ONSITE SEWAGE DISPOSAL SYSTEM

PROPERTY ADDRESS: 2018 Terrapin Creek Road

ON SITE SEWAGE DISPOSAL SYSTEM DESIGN PLAN

LOT 20
TERRAPIN CREEK
PLAT 22661 - 22664
TAX ID No. 03-285774
2014 TERRAPIN CREEK ROAD
THIRD ELECTION DISTRICT
HOWARD COUNTY, MARYLAND
SCALE: 1" = 30' JUNE, 2017

ON SITE SEWAGE DISPOSAL SYSTEM DESIGN PLAN

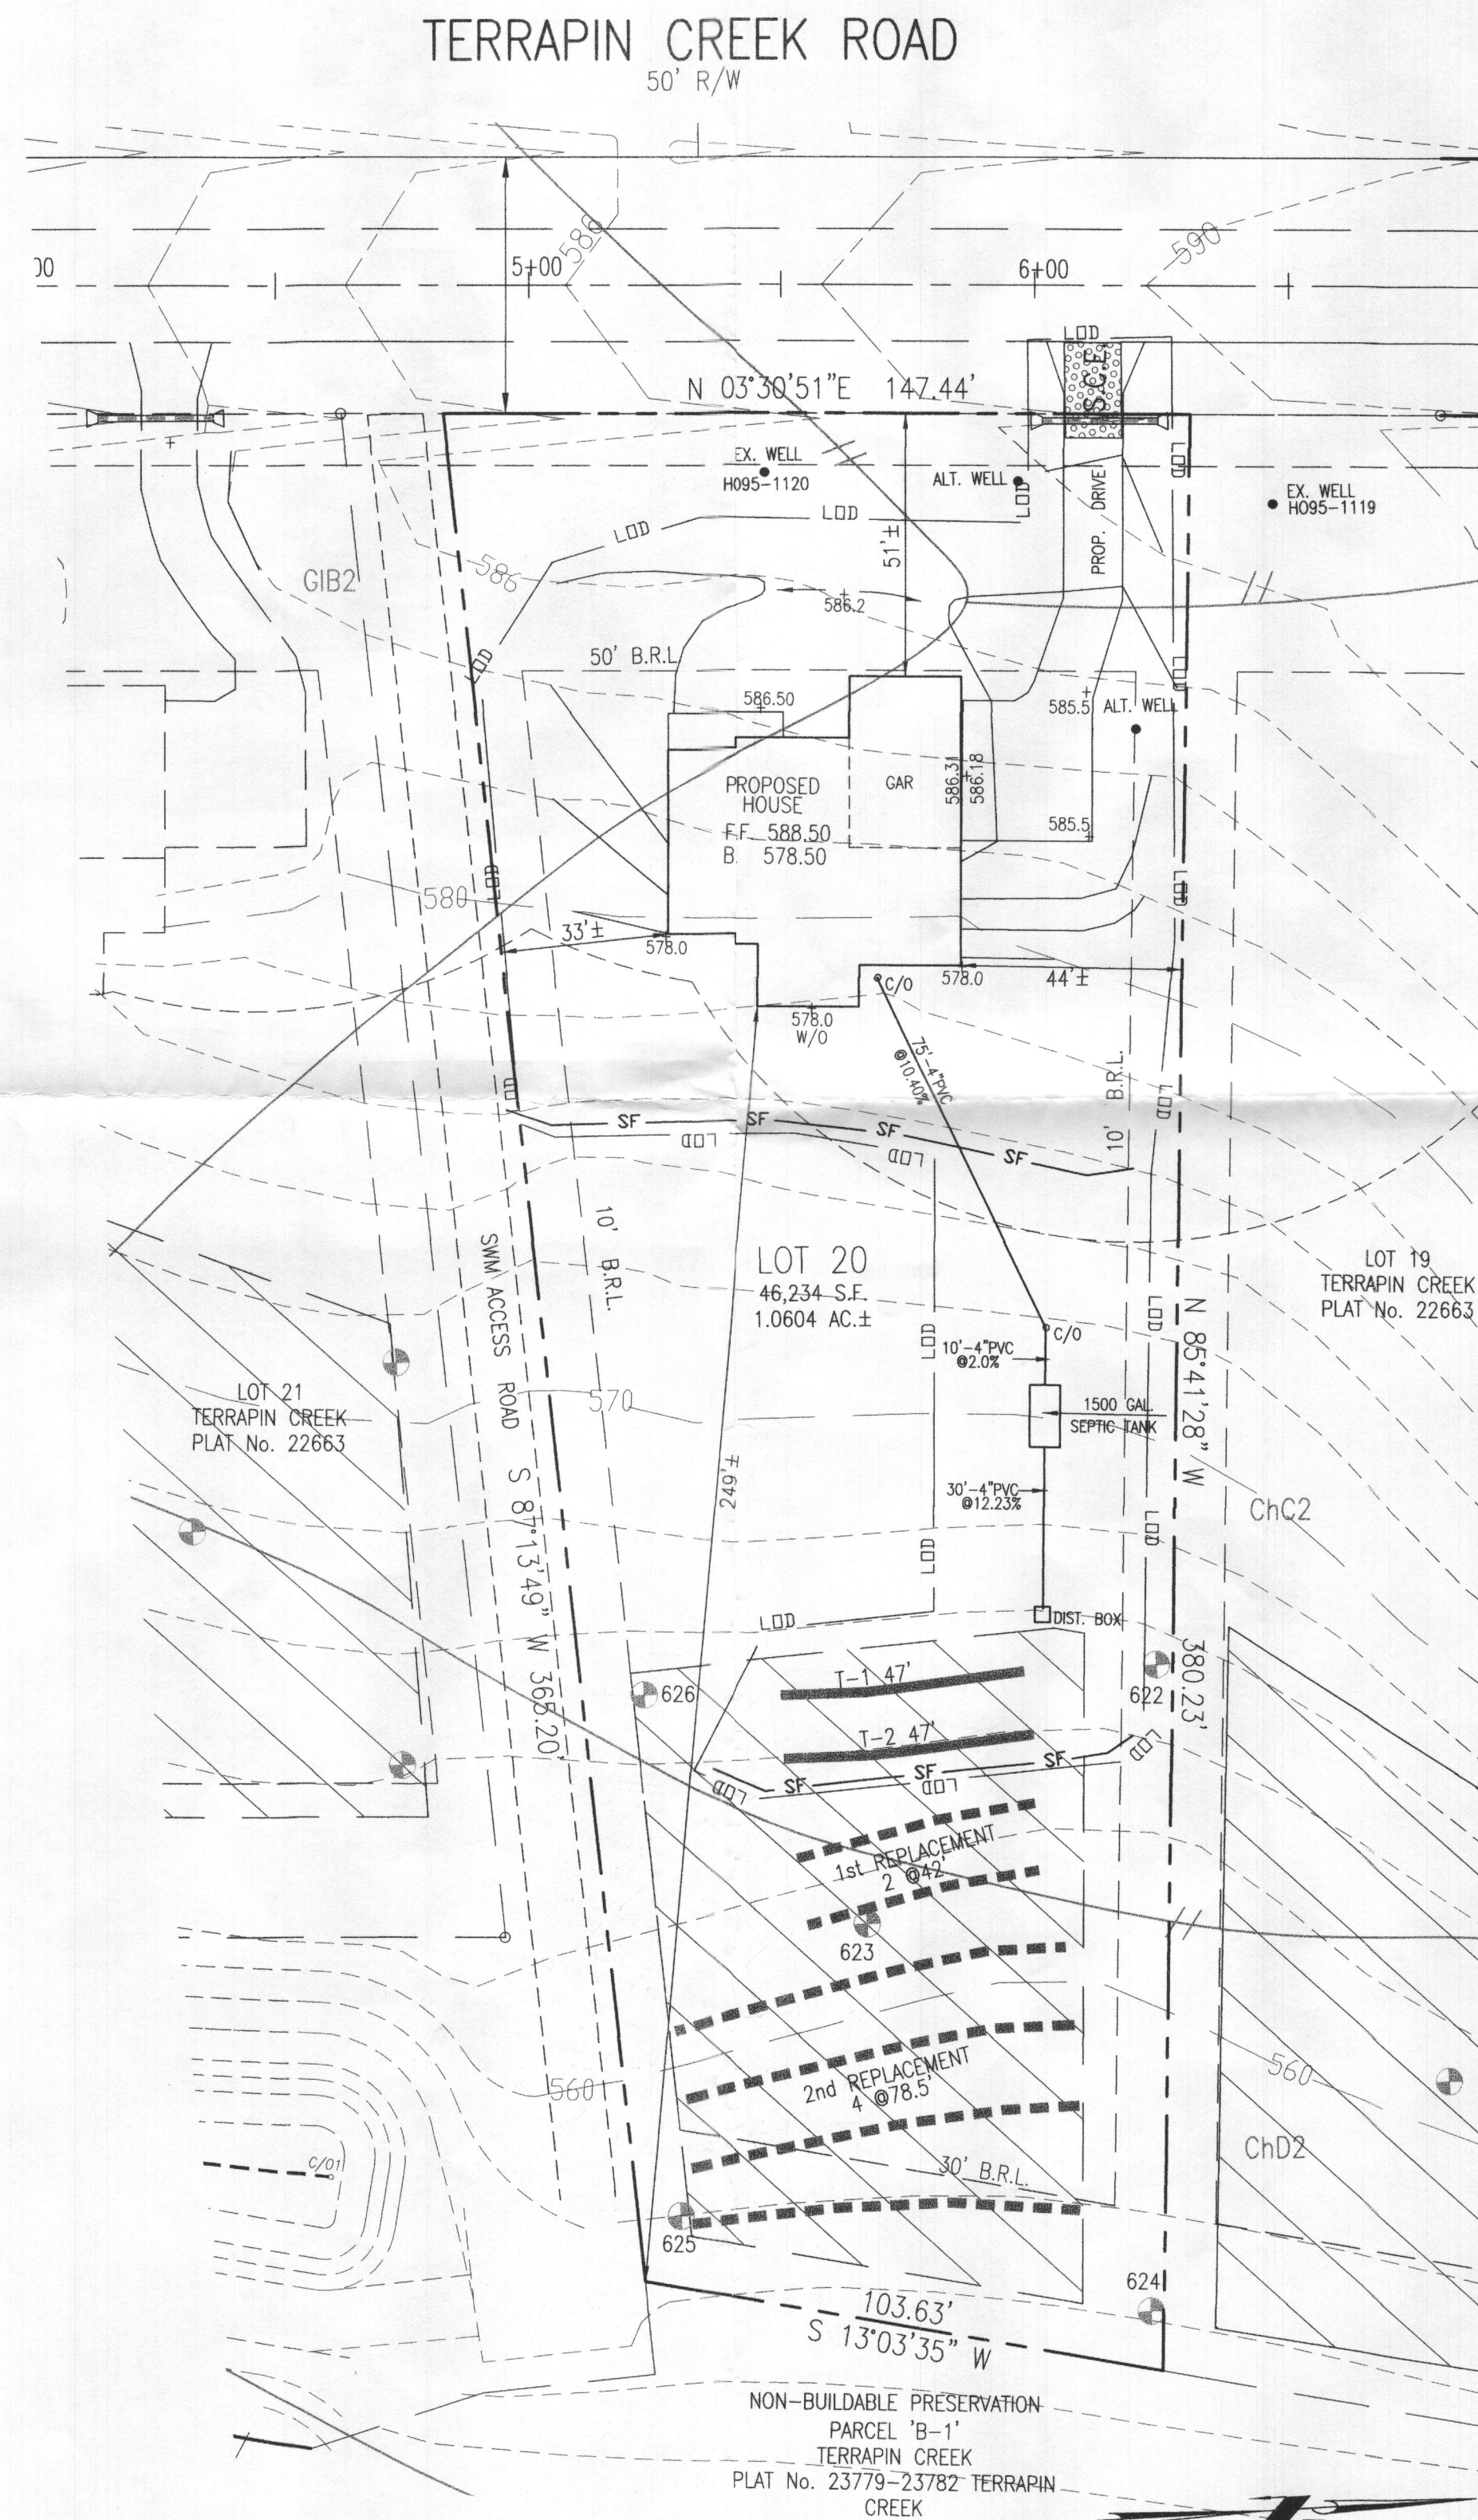
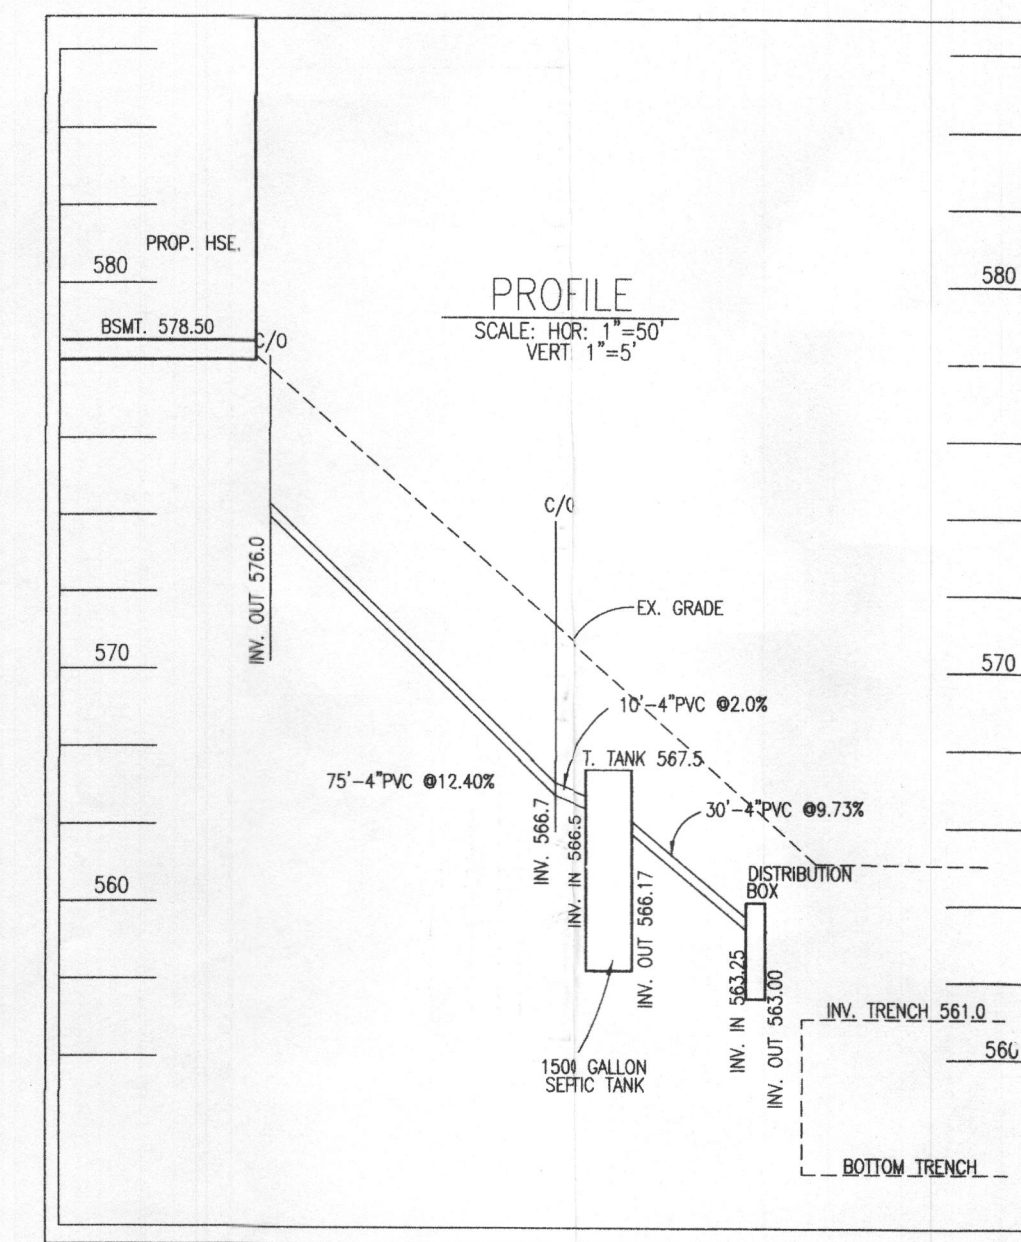
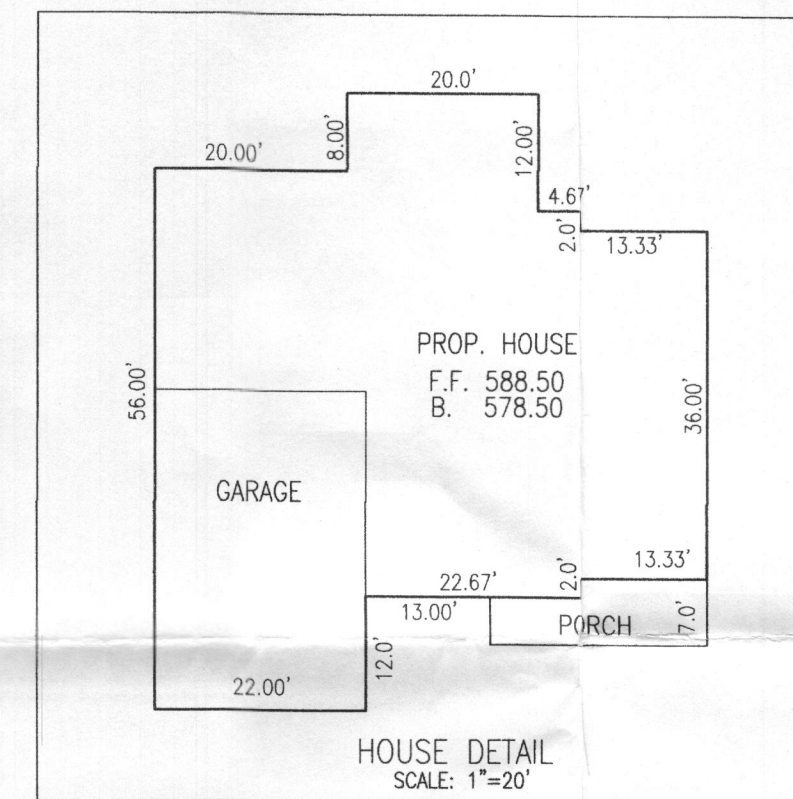
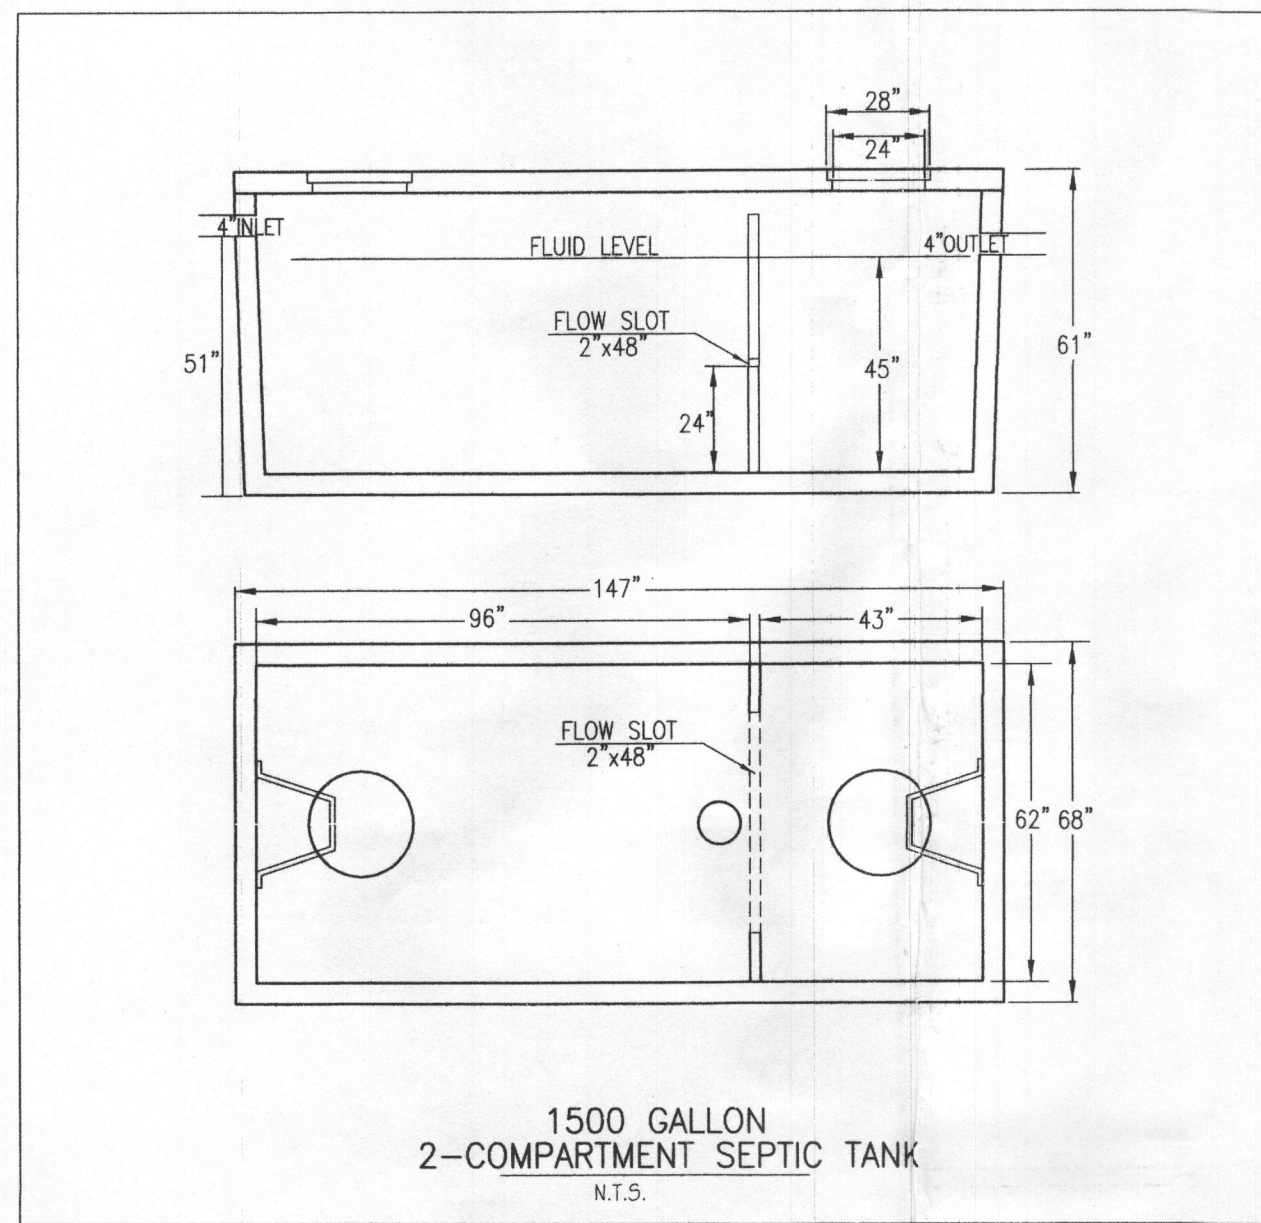
- 1.) Change 2nd replacement system specs to match worksheet (attached)

2nd REPLACEMENT
INITIAL NUMBER OF BEDROOMS = 4
APPLICATION RATE = 1.2 GPD / sq.ft.
DESIGN FLOW: 150 GPD X 4 BEDROOMS = 600 GPD
600 GPD / 0.8 GPD/sq.ft. = 750 sq.ft.
750 sq.ft. / 3 ft. WIDE TRENCH = 250 LF TRENCH
250 LF TRENCH X 1.25 REDUCTION CREDIT = 312.5 LF TRENCH
TRENCH 1 EX. GRD=560.5 -INV. TRENCH=556.5 -B. TRENCH=553.5
TRENCH 2 EX. GRD=559.5 -INV. TRENCH=555.5 -B. TRENCH=552.5
TRENCH 3 EX. GRD=558.8 -INV. TRENCH=554.8 -B. TRENCH=551.8
TRENCH 4 EX. GRD=558.0 -INV. TRENCH=554.0 -B. TRENCH=551.0
